**Director of the Manufactured Housing and
Modular Units Program of the Public Service Commission,
Complainant,**

**America's Home Brokers, Inc.
Respondent.**

Case No. MC-2005-0028

Consumer Complaint Time Line

Kennon Home

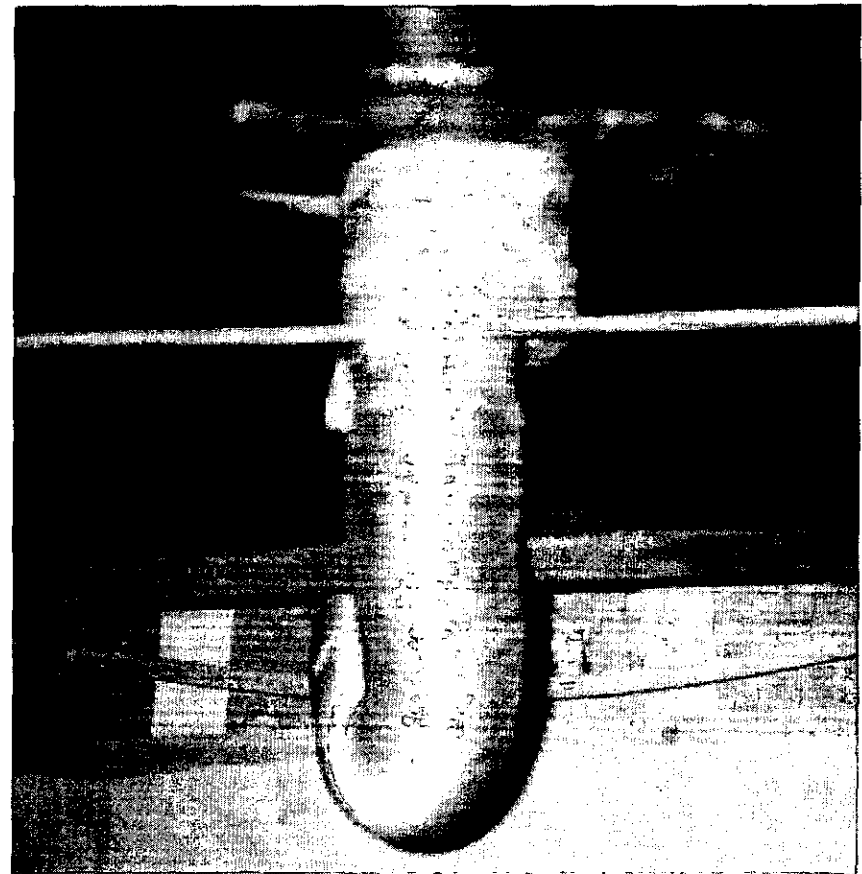
- ❑ 7. d) The combustion air inlet for the fireplace must be properly vented to the exterior of the home.
- ❑ HUD 3280.710(b)(3)
- ❑ IM, page 29

Kennon Home

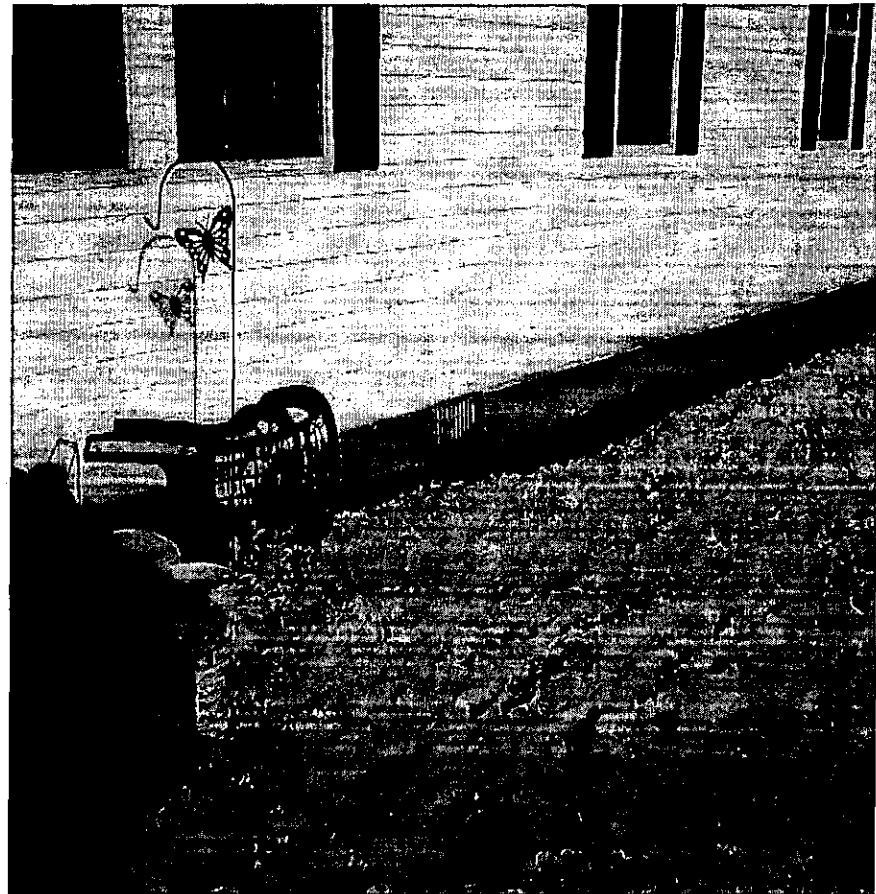
- 7. j) The foundation wall is not properly vented. The manufacturer requires a minimum of 1 square foot of ventilation for every 150 square feet of enclosed area.
- IM, page 20

- 7. j) Continued from previous page
- IM, Page 20

- 7. j) Continued from previous page
- IM, Page 20
- 2027 sq. ft. requires 13.51 sq. ft of net ventilation.
- Home has 3.83 sq. ft of net ventilation.
